SERVICE BULLETIN

ENGINE - LP COMPRESSOR - BIFURCATION PANEL - INCORPORATION OF NEW SEALING PROCESS -
CATEGORY CODE 6 - MOD.ENG-72-0083

V2500-ENG-72-0083

Incorporation of new sealing process
Fig.1(Sheet 4 of 4)

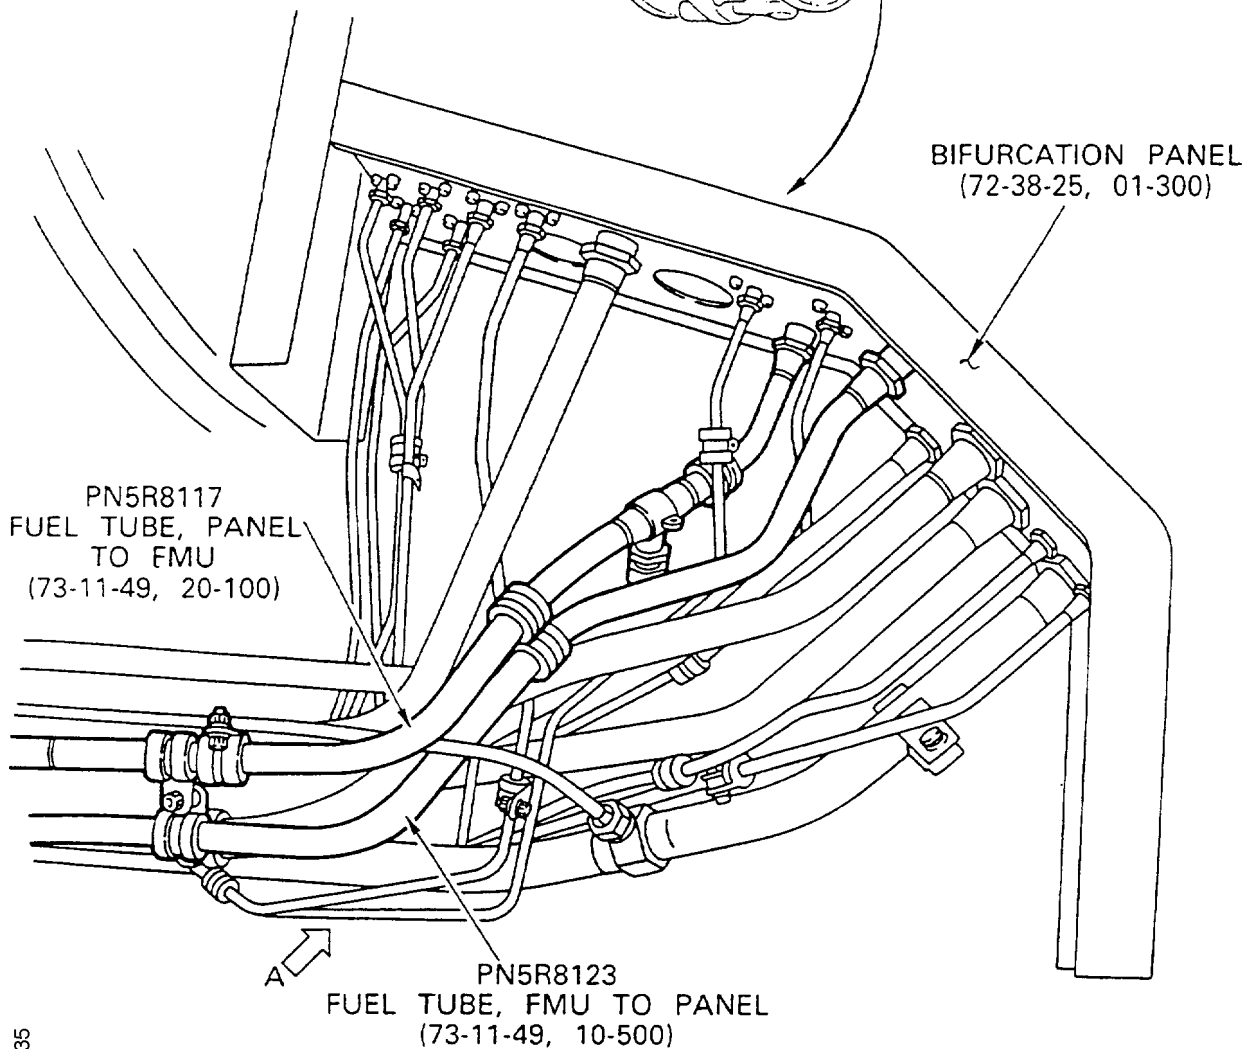
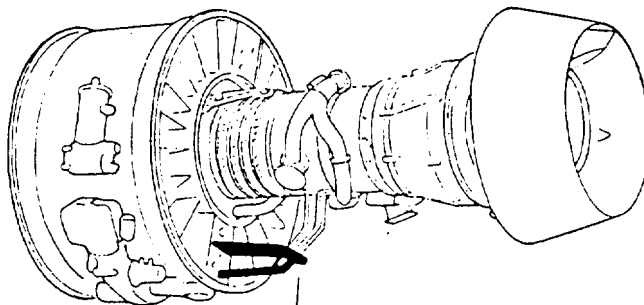
(7) Dry the primer	For CoMat 08-014 primer: (i) Dry in air for 30 minutes For CoMat 08-032 primer: (i) Dry in air for 60 to 90 minutes
(8) Fill the sealant to areas A, B, C and D on the bifurcation panel	Refer to Fig.1 Sheets 3 and 4. Use CoMat 08-013 cold curing silicone compound (silcoset 152) or CoMat 08-074 sealant (RTV159)

- (9) Press the sealant in to positions, Use spatula especially clearances between the bifurcation panel and the fuel tube connectors

NOTE: The sealant should be applied in a thin coating, less than 0.12in. (3,0 mm.) diameter. refer to Fig.1 Sheet 4.

Incorporation of new sealing process
Fig.1(Sheet 1 of 4)

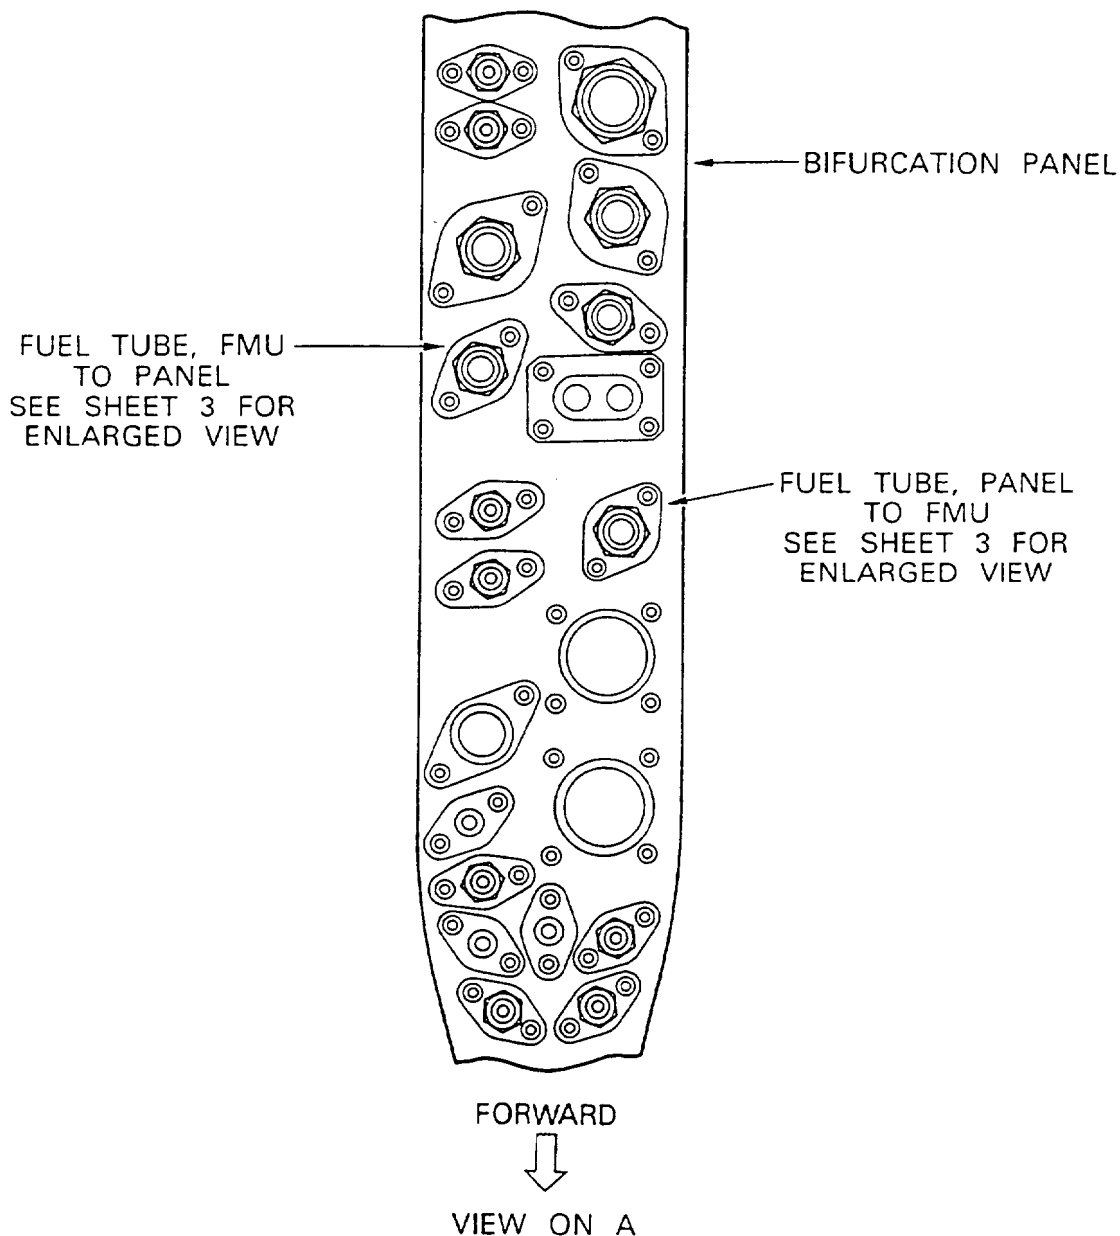
Procedure	Supplementary Information
(1) Find the fuel supply and return tube connectors	Refer to fig.1 Sheets 1 and 2
(2) Clean the surface of areas A, B, C and D on the bifurcation panel	Refer to fig. 1 Sheet 3. Use clean cloth or soft brush made moist with CoMat 01-076 methylethylketone CH ₃ COC ₂ H ₅

Incorporation of new sealing process
Fig.1(Sheet 3 of 4)

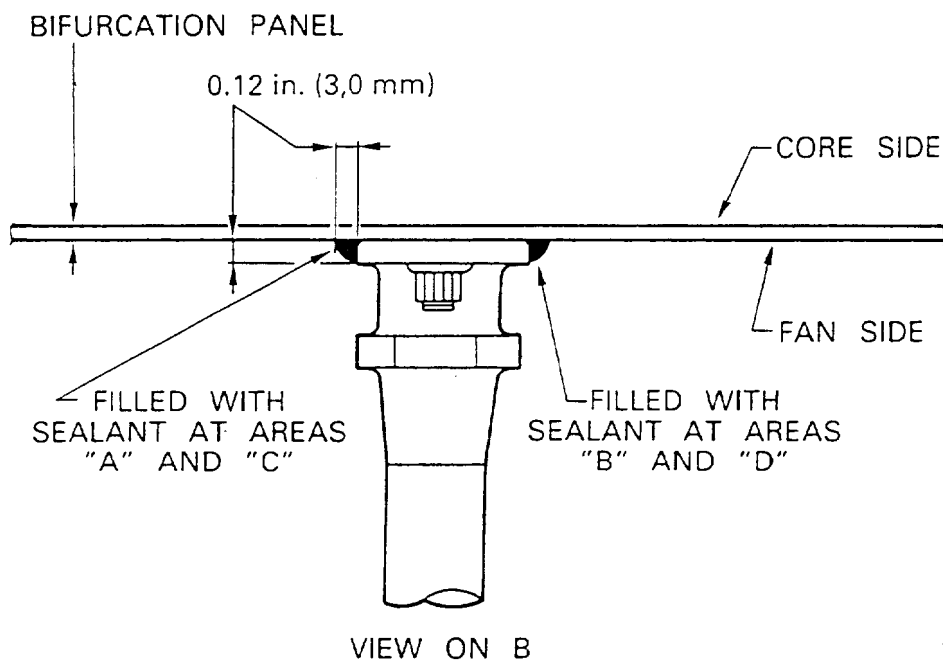
(3) Hand clean the surfaces of areas A, B, C and D	Use CoMat 05-016 garnet paper or CoMat 05-017 garnet paper
(4) Do step (2) again	
(5) Dry the cleaned surfaces	Use dry compressed air or CoMat 02-099 lint free cloth
NOTE: (a) Make sure that there are no remaining cleaners in clearances between the bifurcation panel and the fuel tube connectors.
